Appendix M
Road Safety Audits

Clongriffin to City Centre CBC

City Centre to Kimmage CBC

Road Safety Audit Stage 1

Figure 1 Example of Bus lane with no alternative cycle facilities

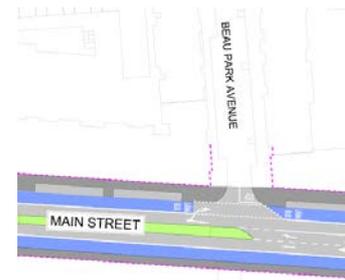
There is inconsistency in the provision of cycle facilities through the project. This could lead to confusion for cyclists putting them in conflict with vehicular traffic.

The design team shall review all locations and ensure there are adequate cycle facilities/ alternative routes provided along the full route of the CBC.

Figure 6 Example of bus gate with no turnabout facilities

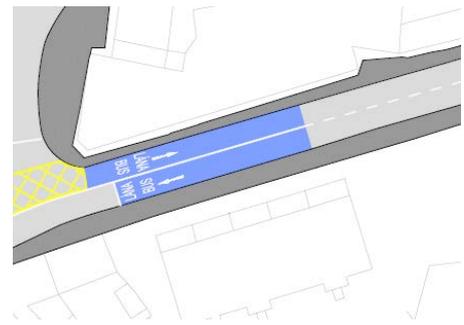
There are a number of bus gates and Cul-De-Sac's proposed where local traffic will be required to perform a turn about. There are no provisions for turning heads to be provided in these locations. This could result in large vehicles such as refuse trucks having to reverse long distances and into other streets potentially putting all other road users at risk of collisions by such vehicles.

Figure 7 Example location where parking is being removed

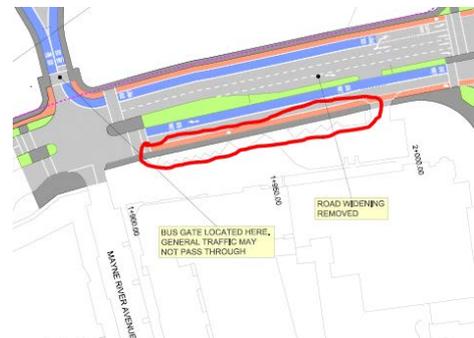
There are a number of areas where existing parking facilities are to be removed in front of commercial and residential premises. If no alternative parking is available vehicles may park on the proposed cycle track forcing cyclists onto the road and into potential conflict with vehicular traffic.

Figure 23 Steps located on Clanbrassil Street

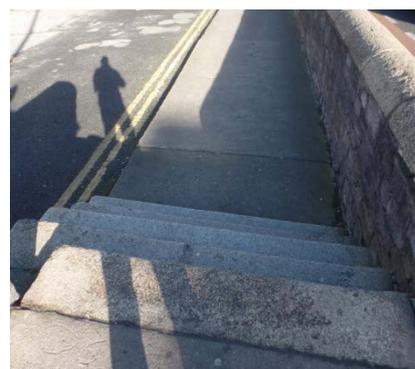
There are currently steps on Clanbrassil Street Upper which will impact on the movements of mobility impaired. These could lead to an increased risk of falls by mobility impaired pedestrians.

The design team shall review design at this location to remove these steps and provide a ramp with suitable gradients for the mobility impaired.

Figure 4.2: Crossing Points along Malahide Road / R139 Junction

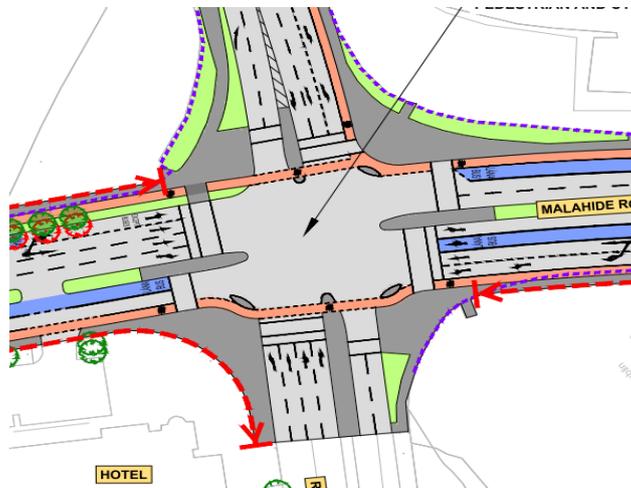
Figure 4.2 & 4.3 below illustrates an example of this problem along Main Street and the Malahide Road, respectively.

Figure 4.3: Bus Stop on Malahide Road

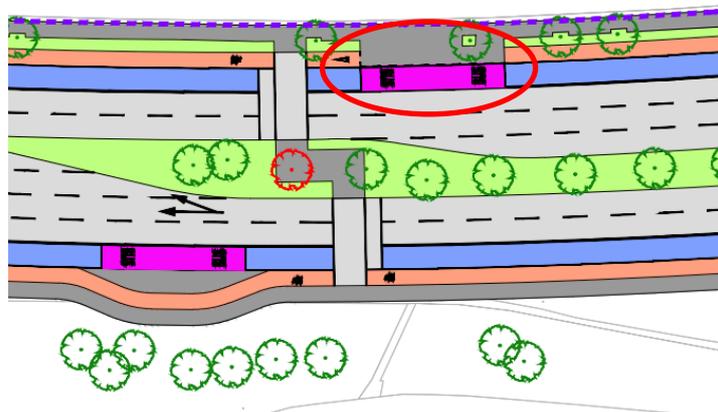
The proposed cycle track along both sides of the Malahide Road pass a shared space between the bus stop and footpath. It is possible that conflicts will occur between cyclists using the cycle tracks and pedestrians waiting at the bus stops or passengers alighting from or entering the bus. Figure 4.3 below is an example of such a layout.

- Sheet 7 of 21: Malahide Road (southbound carriageway)
- Sheet 12 of 21: Malahide Road (southbound carriageway)
- Sheet 16 of 21: Malahide Road (both carriageways)
- Sheet 19 of 21: Malahide Road (both carriageways)

Figure 4.5: Pedestrian Crossing not indicated in the design

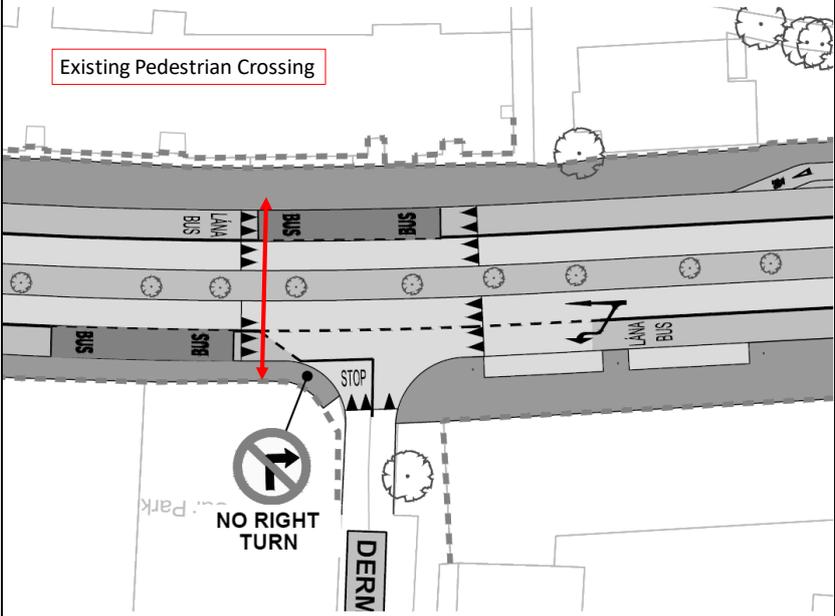
4.3.1 Problem	
<i>Location:</i>	Clongriffin Main Street / Dermot Street
<i>Drawing:</i>	Sheet 02 of 21
<i>Summary:</i>	Removal of Existing pedestrian crossing

Figure 4.10: Proposed Access to Malahide Road

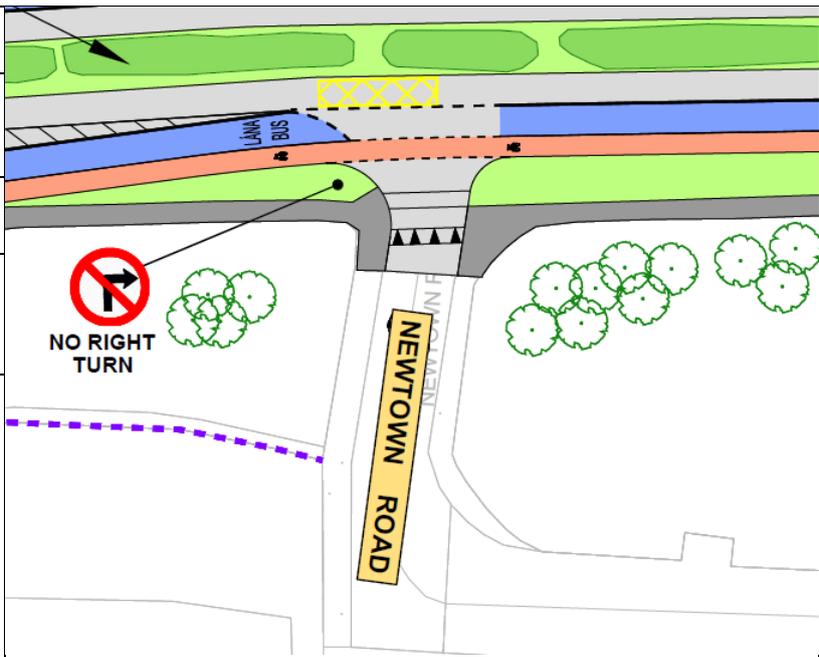
4.3.6 Problem	
<i>Location:</i>	Newtown Road / Malahide Road Junction
<i>Drawing:</i>	Sheet 08 of 21
<i>Summary:</i>	Stop lines and road markings not shown

Figure 4.18: Access to McHugh's off-licence / Artane Auto Centre

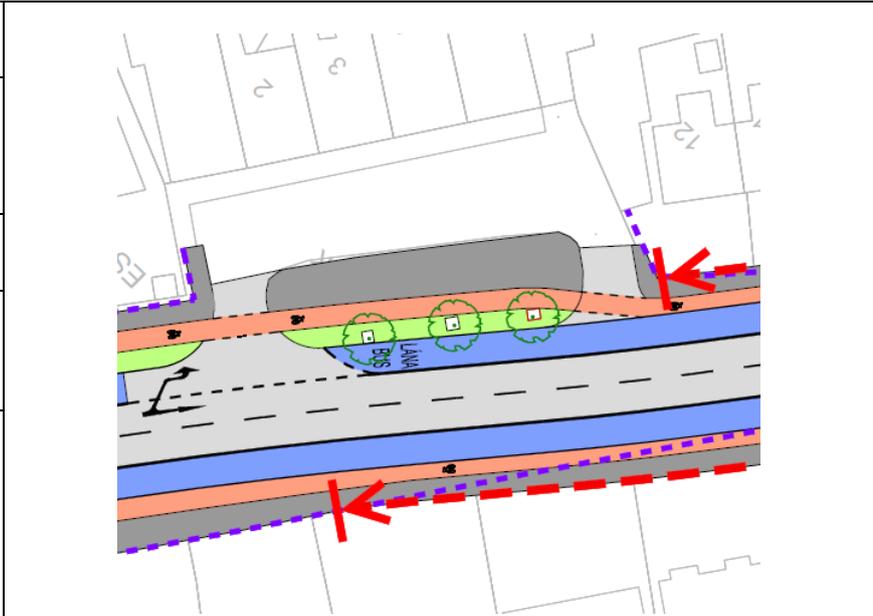
4.3.11 Problem	
Location:	Access to McHugh's off-licence / Artane Auto Centre
Drawing:	Sheet 14 of 21
Summary:	Discontinuation of footpaths

Figure 4.27: Proposed Arrangement

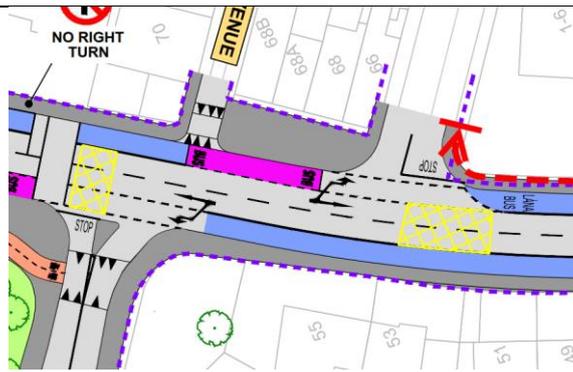
4.3.18 Problem	
Location:	Malahide Road / Marino Avenue Junction
Drawing:	Sheet 20 of 21
Summary:	Pedestrian crossing to be removed

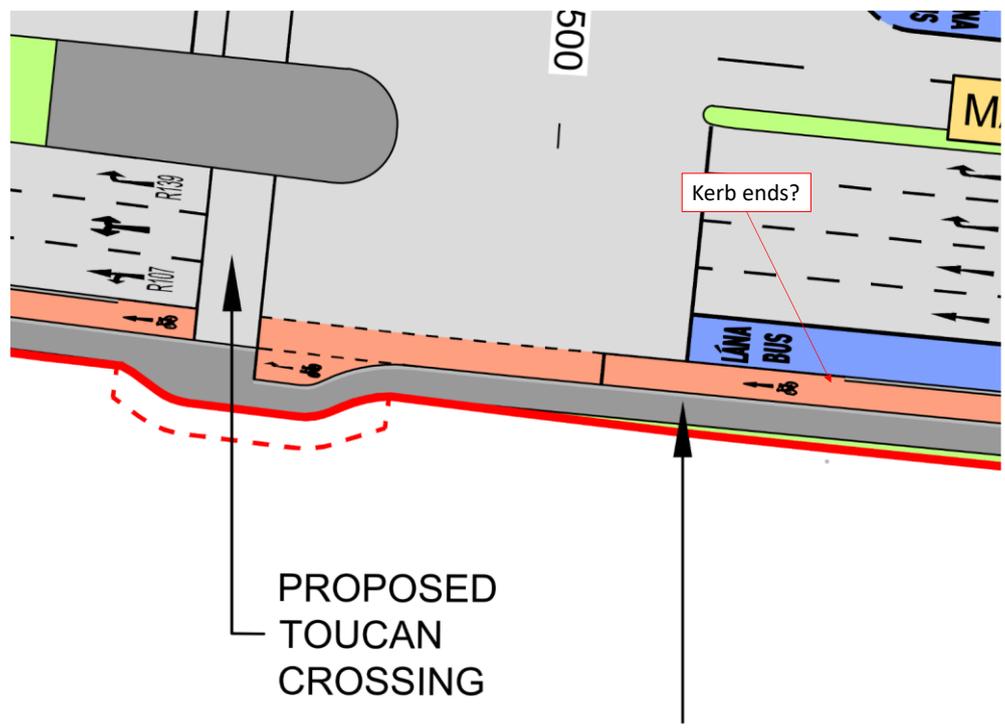
The proposed raised kerb stops short of the stop line on the approaches to some junctions. Cyclists may be vulnerable to some motorised vehicles, cutting into the cycle lane, resulting in a collision.

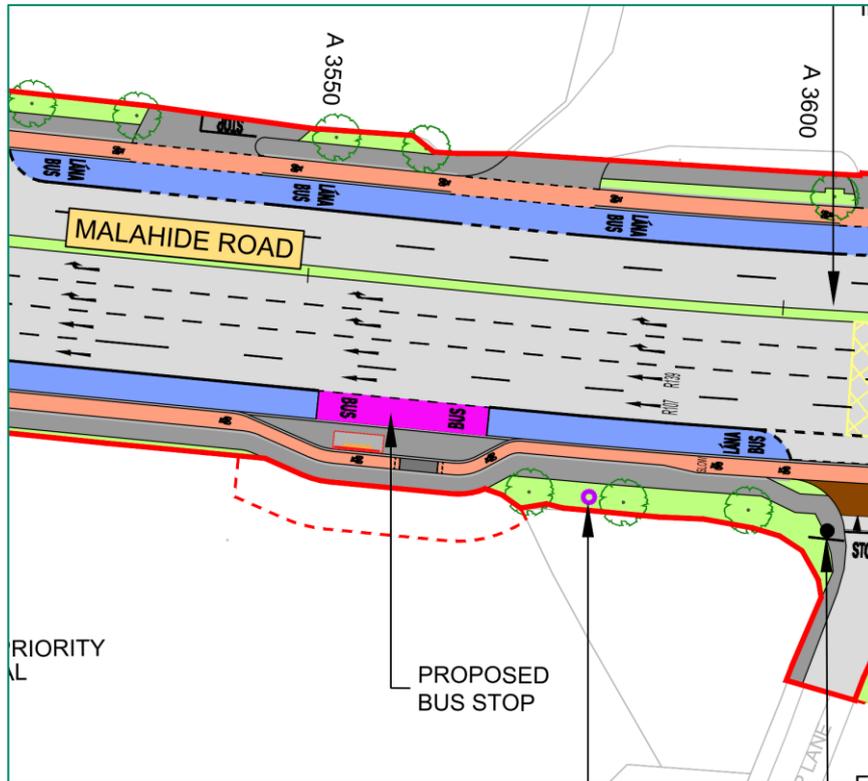
Summary: Cyclists passing Bus Islands

The proposed transition should be increased in length with a larger radius used.

Figure 4.2 – Crossing Points along Malahide Road / Blunden Drive / Priorswood Road junction

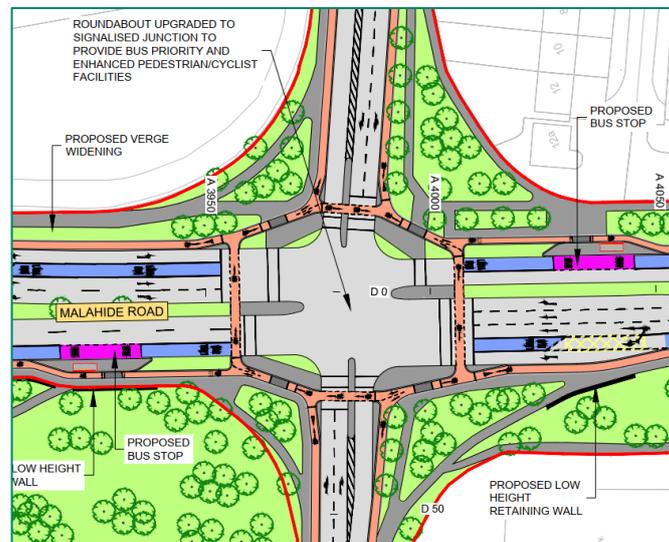
Figure 4.1 and Figure 4.2 illustrates an example of this problem along the Malahide Road.

Figure 4.3 – Malahide Road Markings

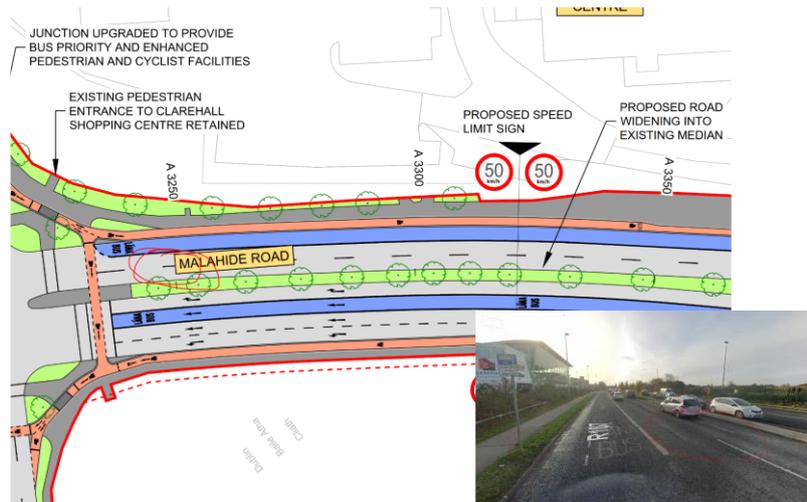
It is unclear from the scheme drawings if the existing road markings are to be re-instated and incorporated into the scheme proposals. Enhancing lane discipline adds to the safety of traffic, besides improving traffic flows. For example in the location shown below, the lack of the arrow road marking may result in someone who is unfamiliar with the area, hesitating, resulting in a rear end collision.

Figure 4.3 illustrates an example of this problem along the Malahide Road.

Figure 4.4 – Protected cycle lane across minor arm along Malahide Road

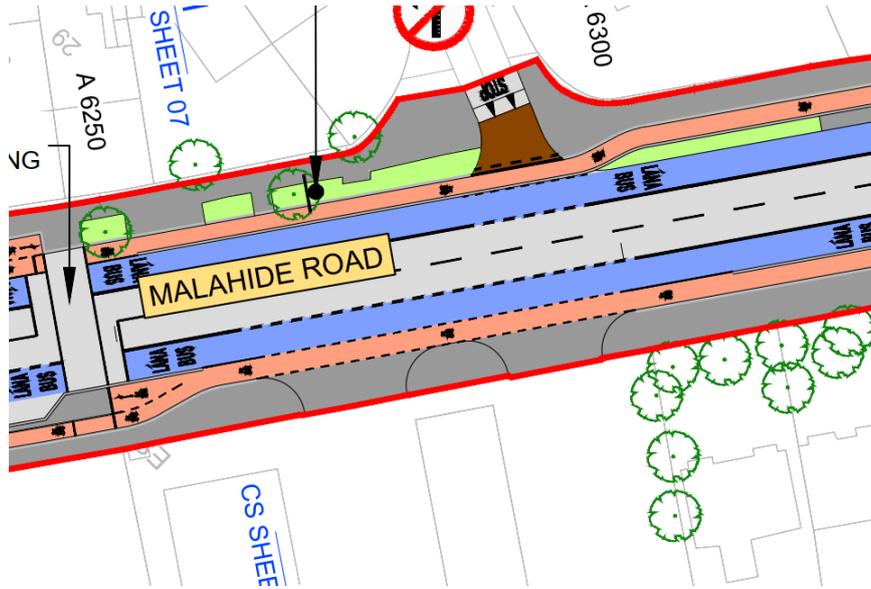
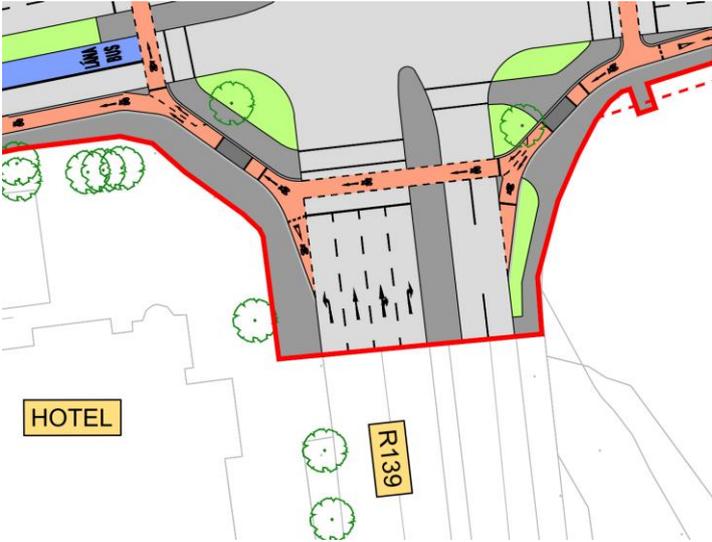
The scheme proposals show the cycle lane being protected by means of a kerb across some of the minor arm accesses but this is inconsistent across the scheme with respect to the minor roads / accesses.

Figure 4.4 illustrates an example of this problem along the Malahide Road where the raised table on the eastern side of the road features a raised kerb and the access on the western side features no protection.

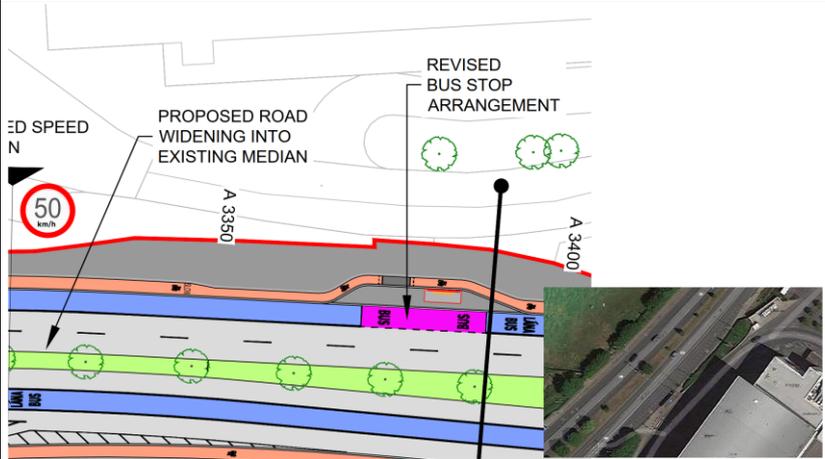
4.3.2 Problem		 <p>Figure 4.6 – Exit of Cycle Lane on R139</p>
<i>Location:</i>	Clarehall Avenue Junction	
<i>Drawing:</i>	Sheet 06 of 21	
<i>Summary:</i>	Cycle signal staging	<p>INDICATIVE METHOD OF CONTROL</p>  <p>Figure 4.7 – R139 / Malahide Road Junction Staging</p>
Description:		
<p>The cycle lane merges with the R139 with a short taper. A stop line and cycle signal are proposed. The cycle signal is proposed at each stage in the signal sequence, even during stages when there is a conflicting traffic stage. If the cyclists are given a green signal, they may believe that they have priority and not check for conflicting traffic movements, resulting in a collision.</p>		
Recommendation:		<p>The cycle signal should be replaced with a STOP or yield road markings or signage. Or alternatively a flashing amber signal should be provided during stages when there are conflicting traffic movements.</p>

<p>The cycle signal should be replaced with a STOP or yield road markings or signage. Or alternatively a flashing amber signal should be provided during stages when there are conflicting traffic movements.</p>

Figure 4.10 – Access to petrol station

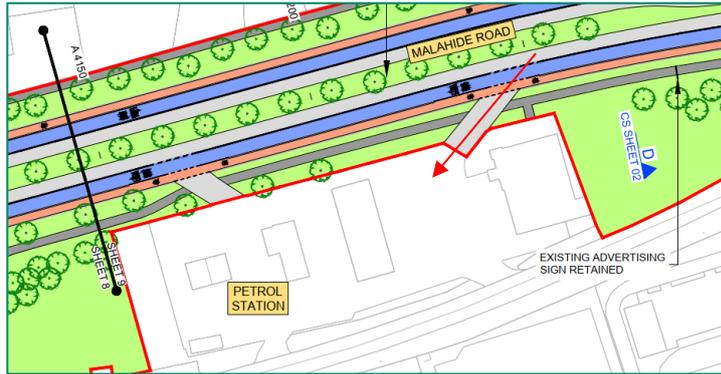
4.3.5 Problem	
Location:	Malahide Road
Drawing:	Sheet 09 of 21
Summary:	Access to petrol station resulting in faster vehicle speeds
Description:

Traffic accessing the petrol at this location (red arrow) were observed to cross the cycle and bus lane at speed given the oblique angle of entry. This could result in instances where a vehicle cuts across the bus and cycle lane at speed resulting in a collision with a cyclist or bus.

The junction radii should be reduced to ensure that vehicle speeds remain slow on entry.

Figure 4.11 – Conflict point between footpath and cycle track

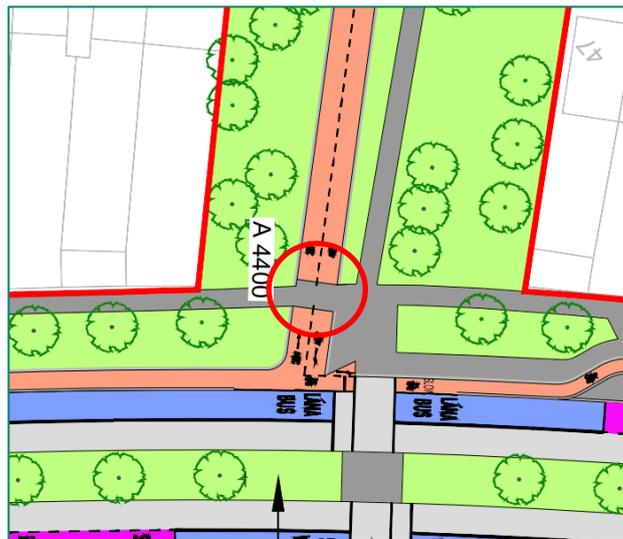
4.3.6 Problem	
Location:	Ayersfield Drive pedestrian and cyclist access
Drawing:	Sheet 09 of 21
Summary:	Unclear priority along cyclist link to Ayersfield Drive
Description:

It is unclear whether pedestrians travelling along Malahide Road or cyclists using the Ayersfield Drive cyclist link have priority at the circled location. If priority is unclear this could result in a collision between a pedestrian and cyclist.

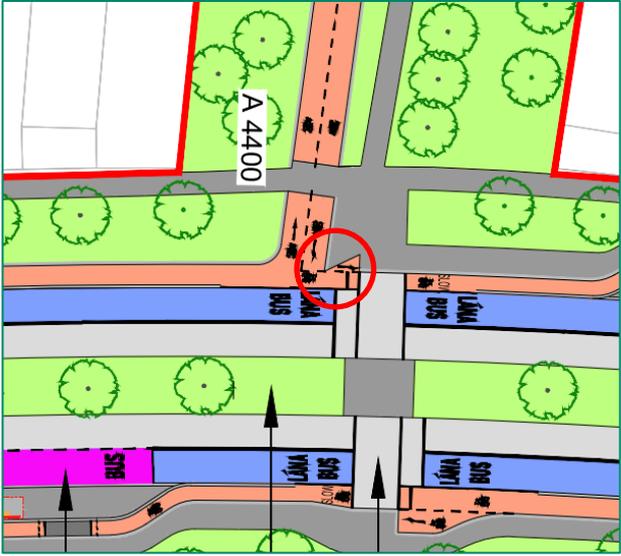
4.3.7 Problem	
Location:	Ayrefield Drive pedestrian and cyclist access
Drawing:	Sheet 09 of 21
Summary:	Straight alignment of cycle lane
Description:	
 <p>Figure 4.12 – Proposed pedestrian and cyclist link</p>	
<p>The audit team are concerned that given the straight alignment of the new pedestrian avenue access to Ayrefield Drive, cyclists may not slow down. This could result in cyclists overshooting the cycle lane and travelling into the vehicle carriageway resulting in collisions with vehicles along the Malahide Road or striking a pedestrian crossing the cycle lane.</p>	
Recommendation:	
<p>Some form of preventative measure should be provided which reduces cyclists speed.</p>

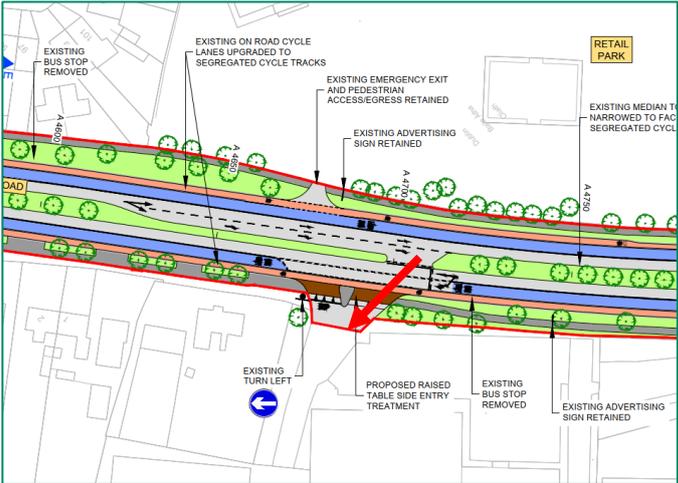
4.3.8 Problem	
Location:	Malahide Road
Drawing:	Sheet 09 of 21
Summary:	Insufficient stacking capacity for jug turn
Description:	
 <p>Figure 4.13 – Proposed Jug Turn for cyclists</p>	
<p>It is proposed at the toucan crossings to provide a jug-turn for cyclists to access the crossing from the cycle lane. The jug-turn to be provided on the southbound approach along the Malahide Road at the Toucan Crossing is noted as having no apparent stacking capacity. This could result in cyclists using the jug turn forcing cyclists travelling southbound along Malahide Road into the bus lane which could result in a collision.</p>	
Recommendation:	
<p>The jug-turn at this location should be consistent with the jug-turn on the northbound approach, and provide enough stacking space for cyclists.</p>

Figure 4.16 – Proposed Arrangement

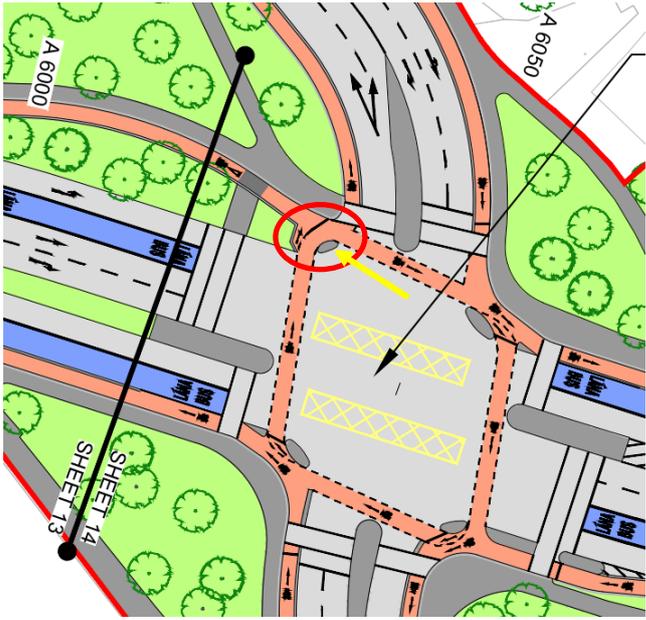
4.3.11 Problem	
Location:	Coolock Village (Brookville Park Road)
Drawing:	Sheet 12 of 21
Summary:	Lack of pedestrian crossing locations
Description:	<p>The audit team note that there are no provisions for pedestrians to cross from the Malahide Road onto the Brookville Park Road. Lack of appropriate crossing locations can present a hazard to pedestrians, particularly vision and mobility impaired.</p>
Recommendation:	Appropriate crossing facilities should be provided at this location.

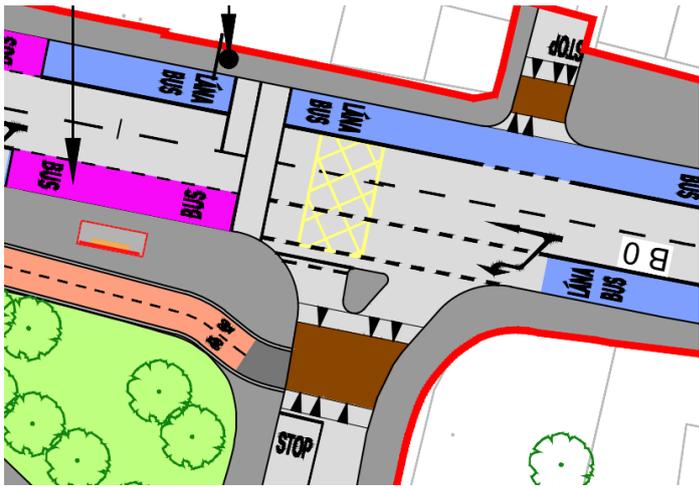
4.3.13 Problem	
Location:	Malahide Road / Gracefield Road / Ardlea Road junction
Drawing:	Sheet 14 of 21
Summary:	Unusual arrangement for right turn pocket
 <p style="text-align: center;">Figure 4.19 – Right turn cyclist pockets</p>	
Description:	
<p>It is proposed that the Malahide Road / Gracefield Road / Ardlea Road roundabout is to be upgraded to a signalised 4-arm junction with protected cycle facilities. At the corners of the junction, a right turn pocket with a stop line is provided for cyclists but the north-eastern corner (circled red) has a different arrangement which could result in a cyclist not entering the right turn pocket and sitting at the concrete island (yellow arrow). Cyclists may not be aware of the intended arrangement which could result in cyclists attempting to cross during a traffic phase and being struck by a vehicle.</p>	
Recommendation:	
<p>The right turn cycle pocket at this location should be consistent with the other right turn cycle pockets at this junction.</p>
